FIFTH EXPLANATION OF SIGNIFICANT DIFFERENCES (ESD)
FOR THE
NEW BEDFORD HARBOR SUPERFUND SITE
UPPER AND LOWER HARBOR OPERABLE UNIT 1 (OU1)
NEW BEDFORD, MASSACHUSETTS
JULY 2015

EPA REGION 1

New Bedford Harbor Superfund Site (Site)
Upper and Lower Harbor Operable Unit 1 (OU1)
Bristol County, Massachusetts

Figure 21a - Conceptual locations of upper harbor CDFs A, B and C
 New Bedford Harbor Superfund Site, ROD 2

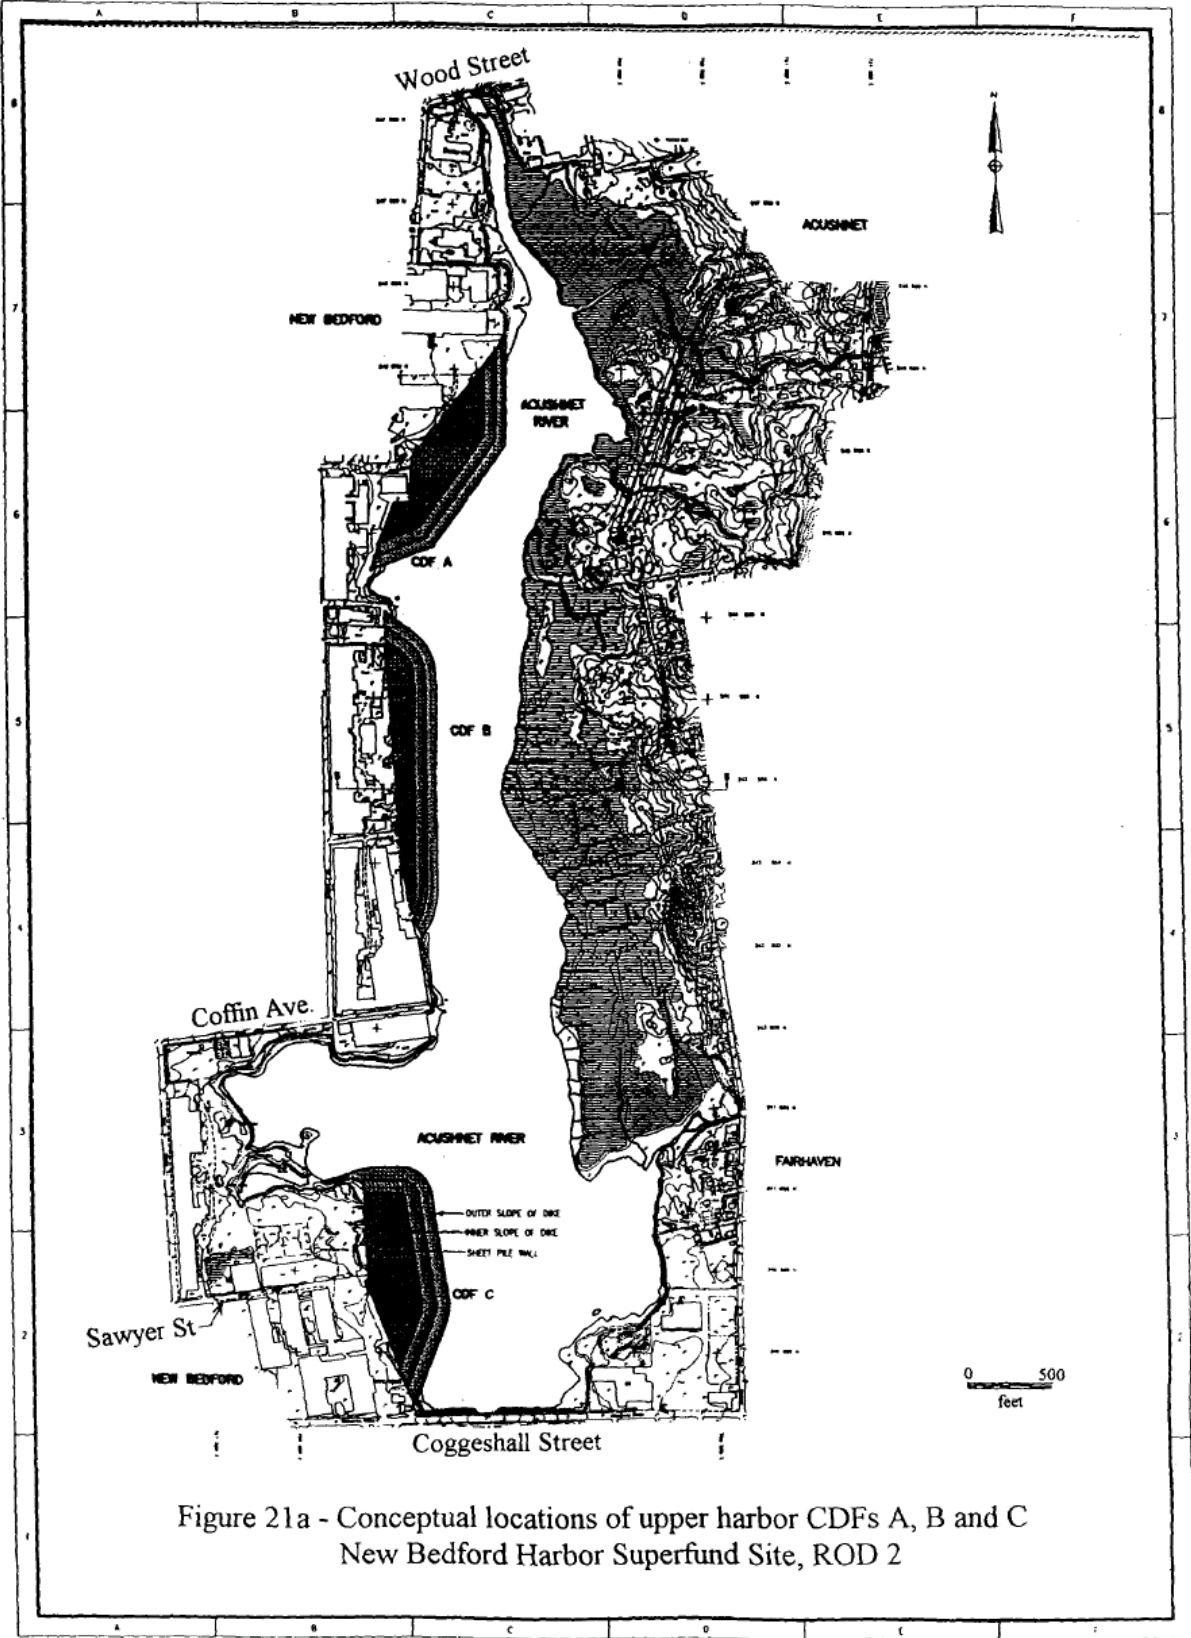
Through this fifth ESD to the OU1 ROD, EPA has modified the remedy for the Upper and Lower Harbor by eliminating the construction of the planned CDFs A, B and modified-C (see discussion in Section II.C, below, regarding modification of the conceptual design of CDF C) and selecting off-site disposal for the sediment slated for disposal in those planned confined disposal facilities. As conceptually planned under the OU1 ROD, CDFs A, B and C were to be shoreline structures (see attached Figure 21a from the OU1 ROD). Note that CDF C was planned for construction at and around the location of the pilot study CDF (see discussion in Section II.A, below, regarding the creation and use of the pilot study CDF). As such, the Pilot CDF is located within the footprint of the conceptual location of CDF C.

Considering the potential effectiveness and implementability concerns associated with CDFs, the longer timeframe needed for CDF construction and utilization, and the higher estimated cost of CDF disposal as compared to off-site disposal, EPA, through this fifth ESD, is eliminating CDFs A, B and modified-C as a disposal element of the OU1 remedy and instead selecting off-site disposal for the approximately 175,000 cubic yards of *in situ* contaminated sediment currently slated to be disposed of in CDFs A, B and modified-C.

Monitoring Well Locations New Bedford Harbor Sawyer Street CDF New Bedford, MA			 Figure Number 1
	SCALE	DATE	PROJECT NO.	
	1:1300	08/14	80317716

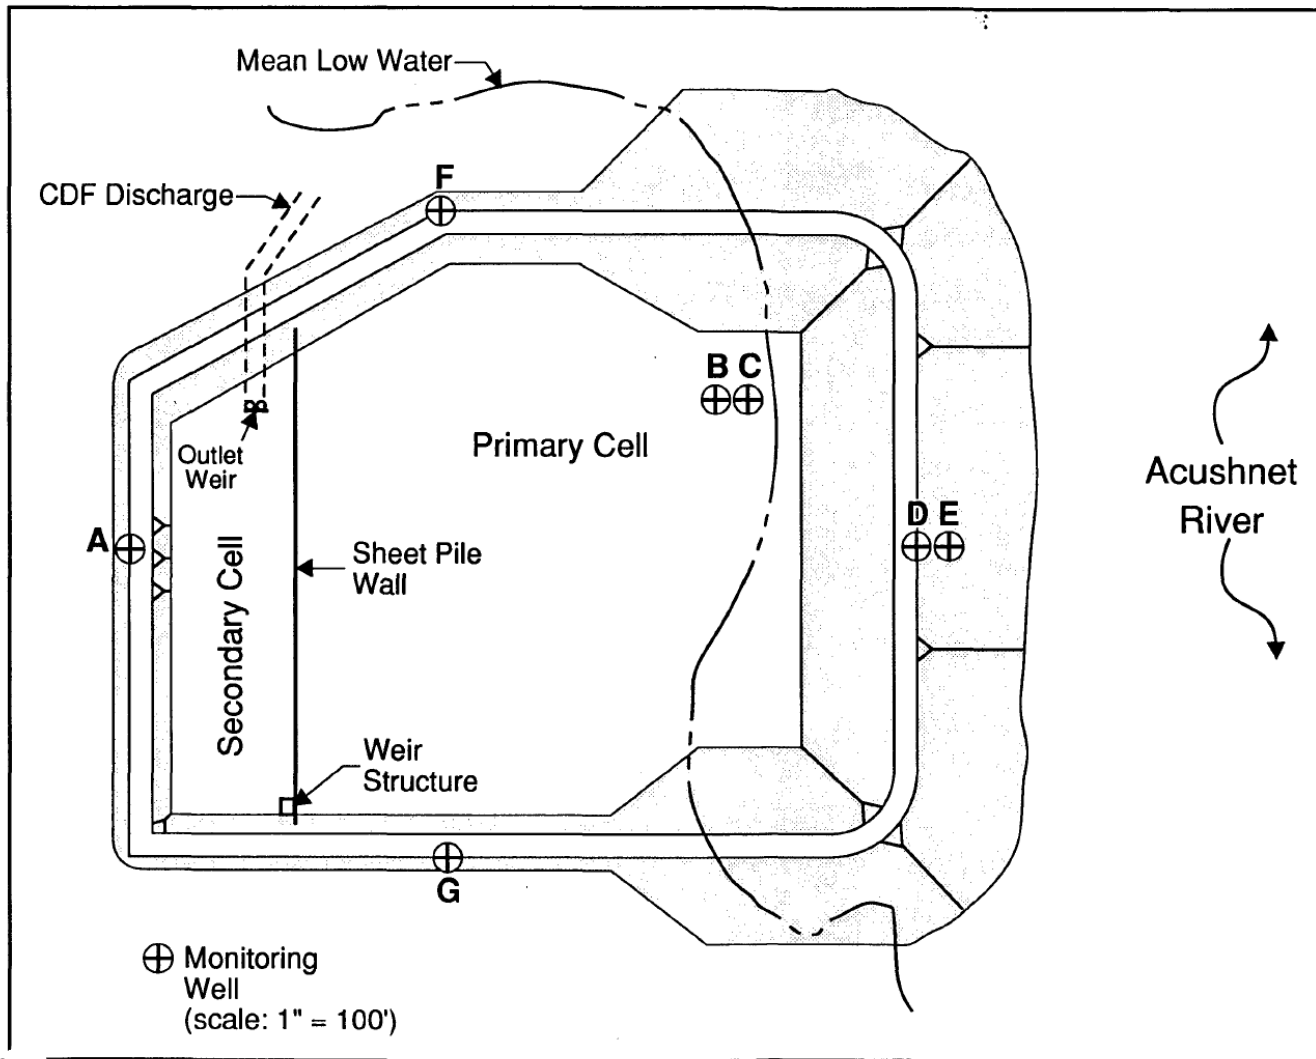
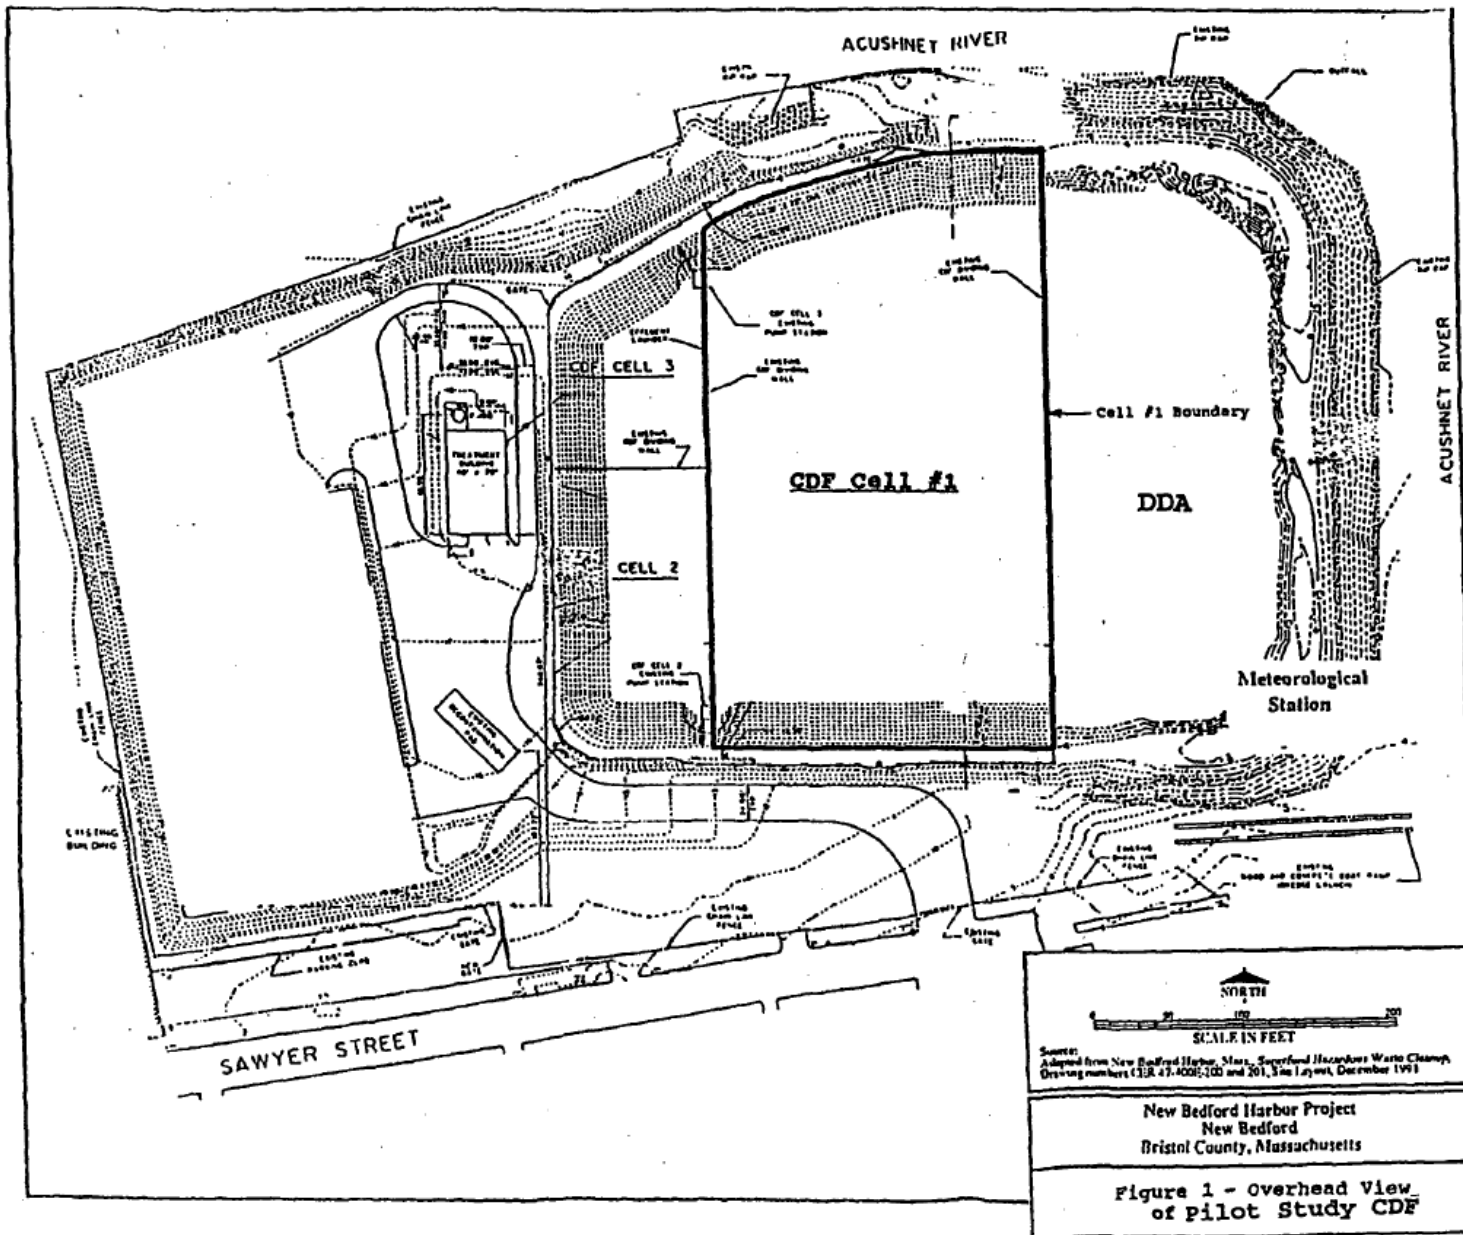
Groundwater and air monitoring performed at the Pilot CDF since 1992, along with groundwater modeling, demonstrate that PCBs are not migrating from the Pilot CDF area. See attached Figure 1 from the Sawyer Street Semi-annual Groundwater Monitoring Technical Memorandum showing location of groundwater monitoring wells. As noted in ESD1, underlying the Pilot CDF is a clay layer sandwiched between the Pilot CDF contents and the underlying sands. The clay layer acts as a naturally impermeable barrier to the movement of contaminants from the area. The constructed dike serves as three sidewalls of the Pilot CDF. Due to the type and quantity of materials used to construct the dike, these sidewalls have moderate permeability with an estimated hydraulic conductivity of 3 ft/day. Although these sidewalls are not impermeable, the over 20 years of groundwater monitoring data demonstrate that PCBs are not migrating. The sheet pile wall that serves as the sidewall separating the Pilot CDF from Cell #1 is impermeable. Consistent with the process described in ESD1, since the monitoring and modeling performed to date of the Pilot CDF confirm that PCBs are not migrating from the area and given the subsurface and sidewall features, the Pilot CDF is made an element of the final remedy.
